Submitted with  
proposed amendment  
at Interview on  
1 July 1988

FIG. 5

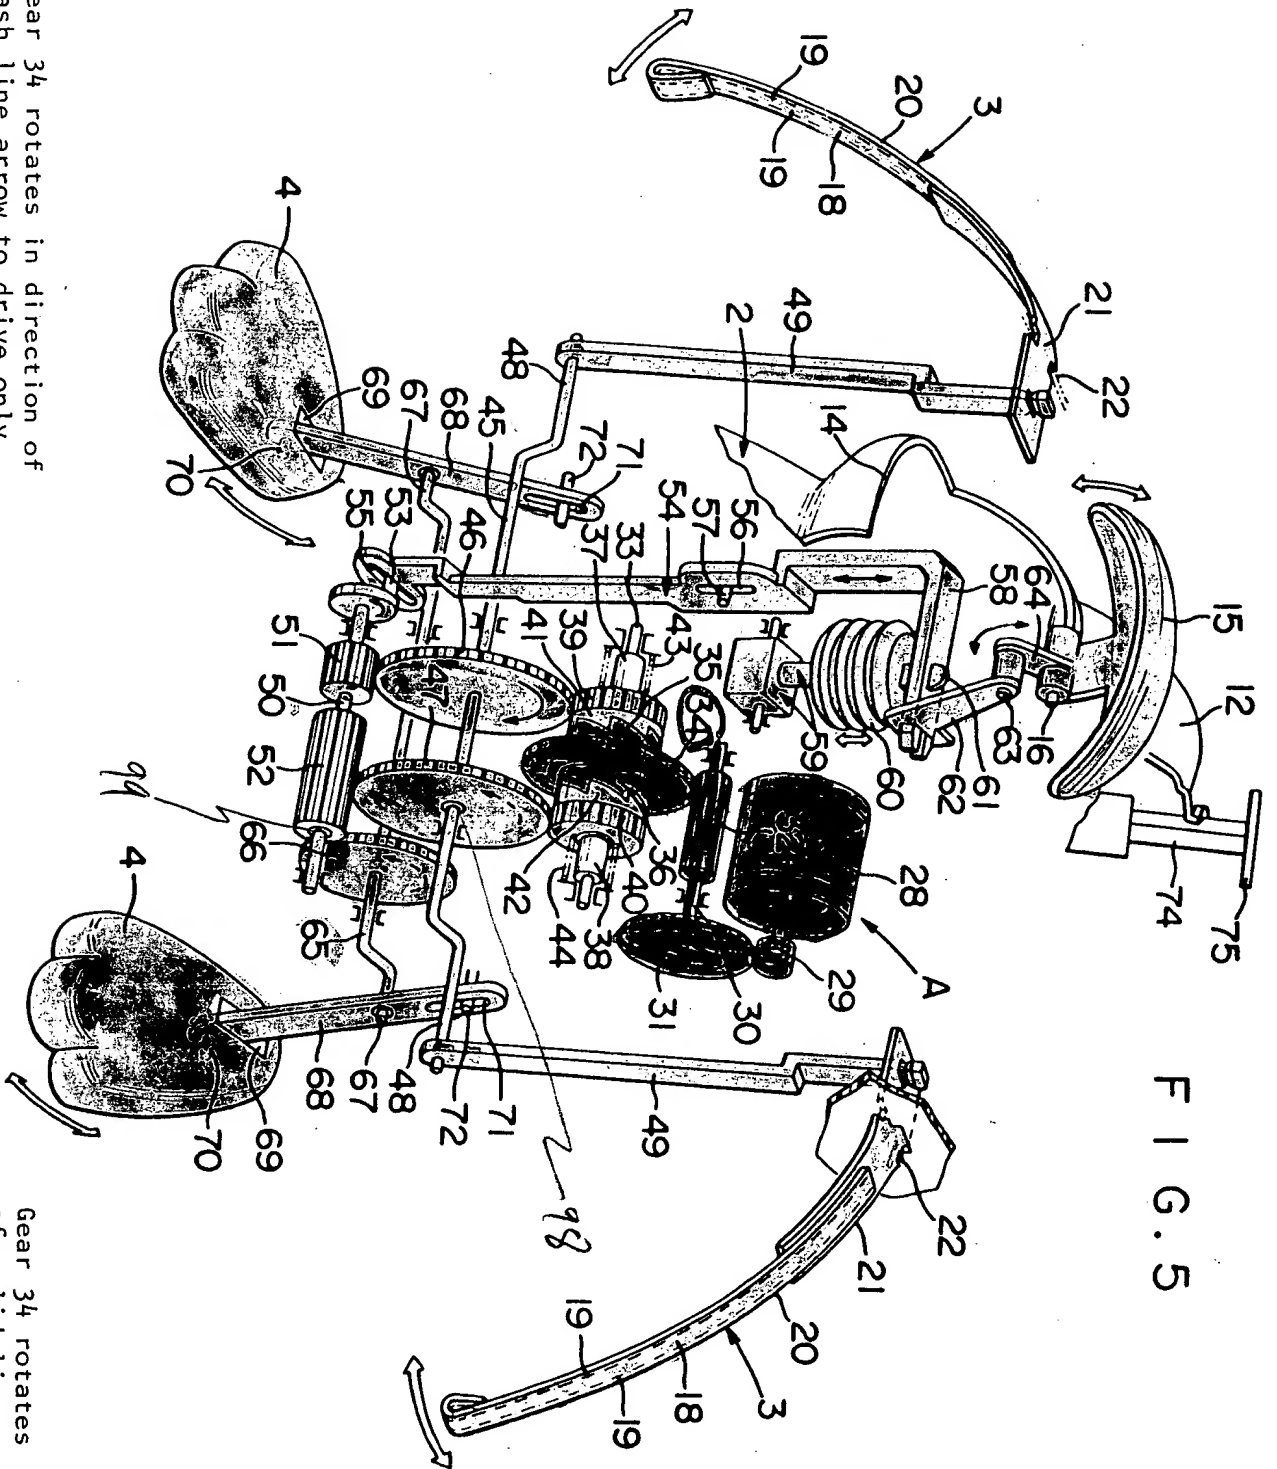
Gear 34 rotates in direction of  
dash line arrow to drive only  
green leg components.

Gear 34 rotates in direction  
of solid line arrow to drive  
only blue arm, mouth and sound  
components.

~~FIG. 5~~

FIG. 9

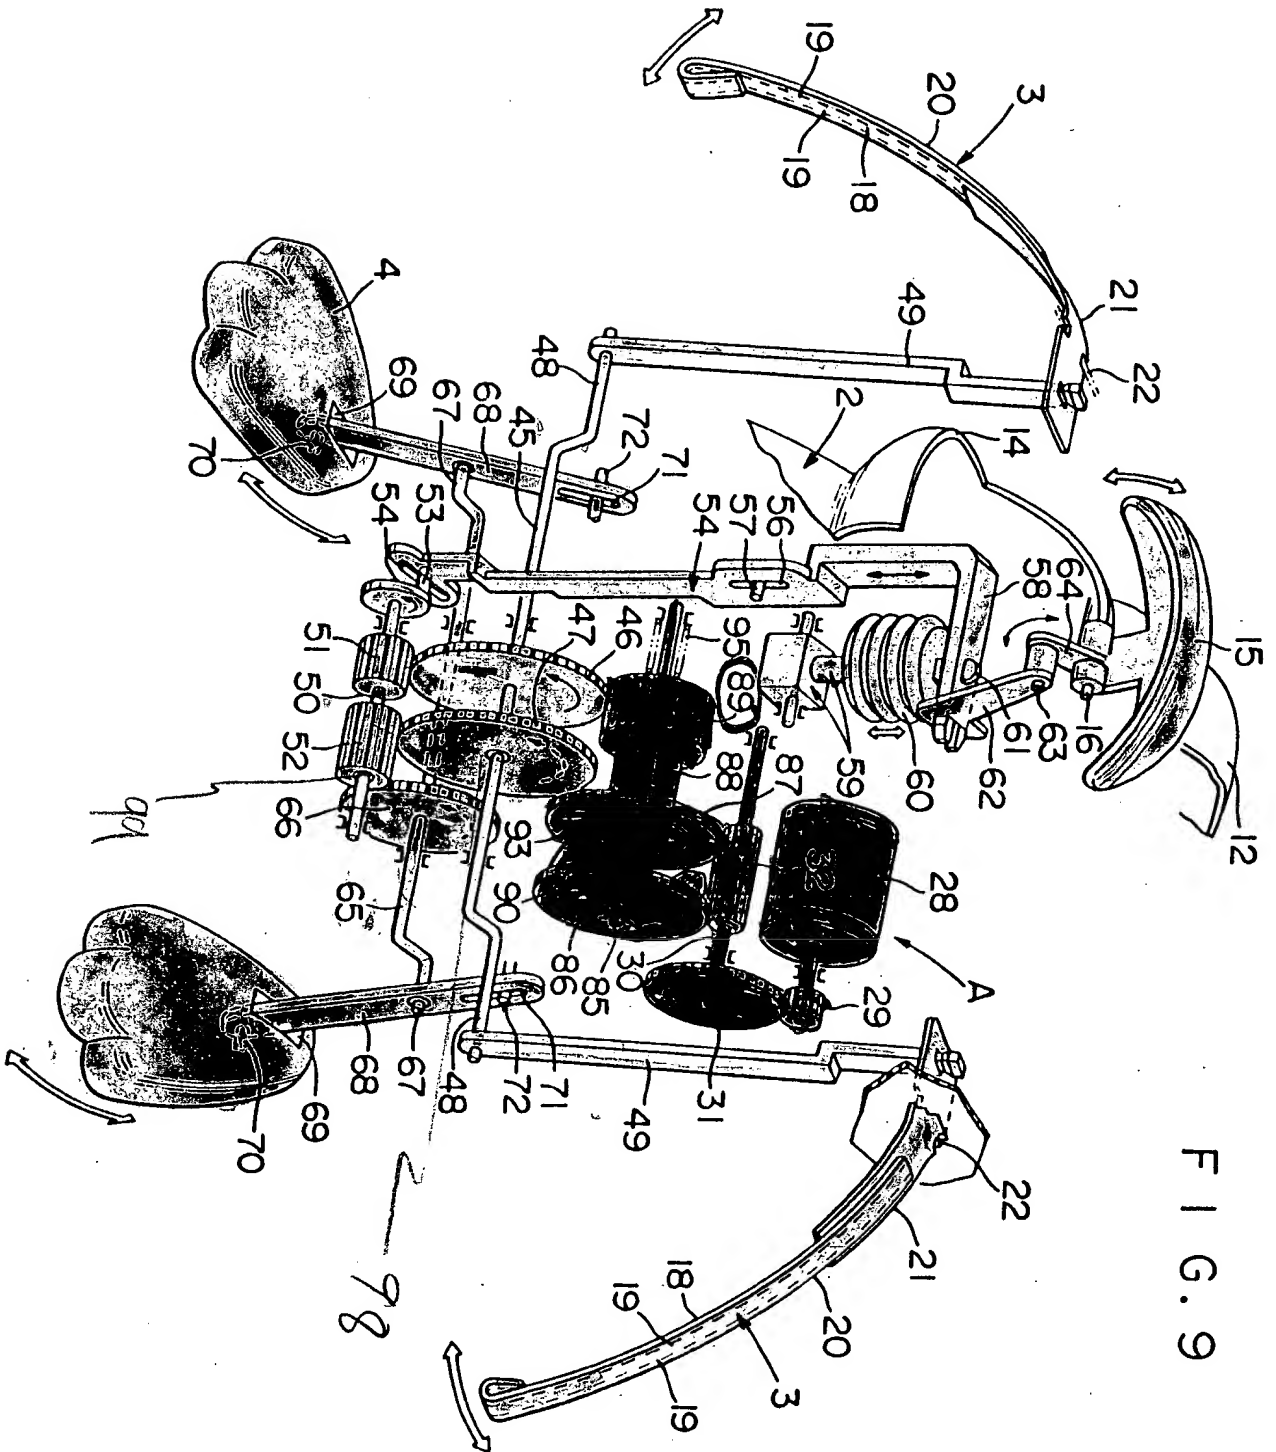
Gear 89 slides to the left to  
drive only blue arm, mouth and  
sound components.

Gear 89 slides to the right to  
drive only green leg components.
